# **RFP # BLR-240001**

## **Final Questions and Answers – through 03/12/2024**

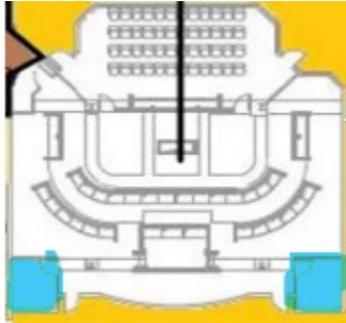
**Q8.** Are the two (2) offices referred to as “on the sides” of Committee Room B, the BLR Library and the Map Room?

**A8.** No, the “on the side” offices are highlighted in blue in the picture below, they are part of the committee room.
